Our Reference: 41901-01 [ID 951362]
Council Reference: OPW/2023/311

**Civil Engineering
Project Coordination**

Re: Response to Information Request for Operational Works Development Permit Application; over Lots 188, 190, 191, 192 RP173728, 79 Courtney Drive, Upper Coomera

Figure 1: batters within Park Lot 1005.

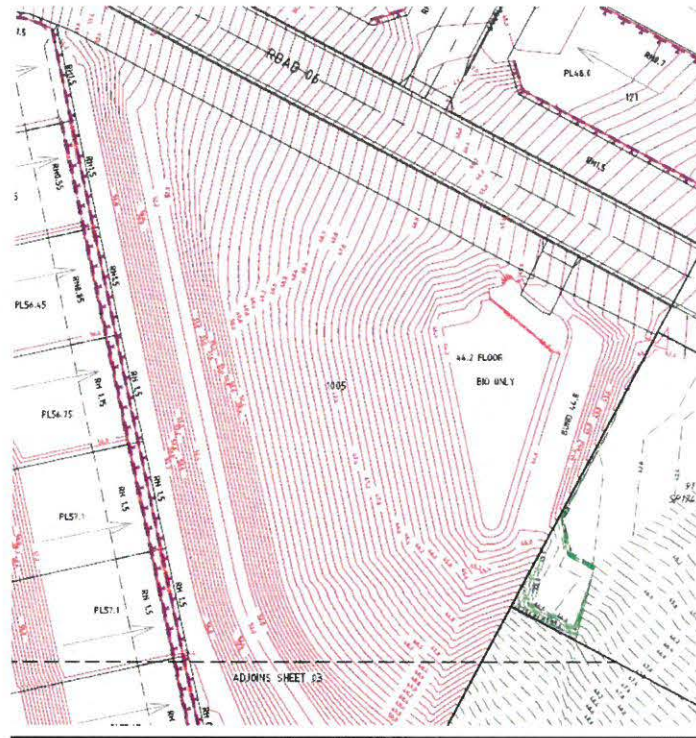
Item 8 Batters within Lot 1005

In pre-lodgement meeting discussions between the applicant and Council a batter design of maximum 1:2 batters of generally 2m high was agreed to, with a 1m bench in-between each batter, to facilitate safe pedestrian access for Council staff and contractors. Whilst this is generally in accordance with this design the applicant is requested to demonstrate the following:

- a. *No batters of a steeper grade than 1:2 within Park Lot 1005. All batters must be 1:2 or less;*
- b. *Provide a 1m wide maintenance access bench to any 1:2 batters that are 2m high;*
- c. *Include a 1m maintenance access bench provided between the change in batter grade at the 50m contour level; and*
- d. *Provide a 3m wide maintenance access track around the bio-basin.*

During the ROL phase of the development approval, it was agreed within correspondence between Mr Antony Kocsmar and Mr Brad Comley dated 3rd September 2020, council advised the following:

"City officers have discussed the options presented for park lot 1005 and option 2 can be accepted from an Open Space assessment perspective. This however, does not negate the need for the applicant to demonstrate that compliant access can be achieved to the basin floor or perimeter in accordance with the Land Development Guidelines / Water by Design."

Option 2 is shown below, and this is the basis of the current OPW design. As shown the maximum batter grade is 1:2 and the benches are provided as per the agreed position. Acceptance of this outcome has been reflected within the ROL decision notice under condition 25 being Safety Anchor points.

Figure 2: batters extending from Park Lot 1003 drainage reserve extending into Park Lot 1004

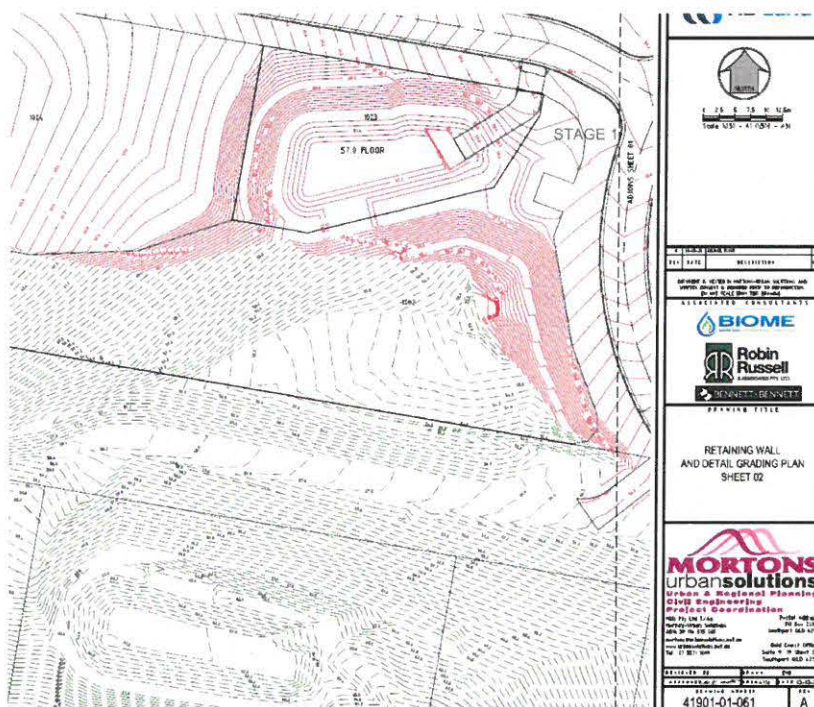
Item 9 Batters within Drainage Reserve 1003

In pre-lodgement meeting discussions between the applicant and Council a batter design of maximum 1:2 batters of generally 2m high was agreed to, with a 1m bench in-between each In accordance with condition 26 of the overriding approval the applicant is requested to amend plans to ensure all batters associated with park lot drainage reserve Lot 1003:

- a. *Not extend into the adjacent Park lots dedicated for the purposes of recreation (non- trunk) or conservation.*
- b. *Batters associated with each Bio basin within the drainage reserve be fully contained within each lot.*

We note that Condition 28a of the ROL Approval dated 20 June 2023 now overrides this request and therefore the plans have not been amended as they are compliant with the condition. Please see below Condition 28a.

28	Batters within Drainage Reserves <i>(specific condition)</i>
a	All batters associated with Open space (Drainage) lots being Lot 1003 and Lot 1009 are required to demonstrate the following:
i.	Where it is deemed necessary through a subsequent Operational works approval for Civil works for batters to extend into the adjoining Open space (Environmental) lot being Lot 1002 and 1011, the extent of batters within adjacent lot 1002 and 1011 must be generally in accordance with Morton's Urban Solutions Preliminary Earthworks Plans (drawing reference 36001-PRE- 101-105, Rev E dated 16/12/2021) and earthworks associated with the batters must be reflected within the approved rehabilitation management plan as per Condition 49.

In addition to the above condition the client's planners provided correspondence and calculations to council confirming that the adjacent open space (lot 1004 and 1010) complied with the council's park design guidelines as parks provided have a grade of 1:10 or less for more than 80% of their total area, thus making the batter encroachment from lot 1003 acceptable.
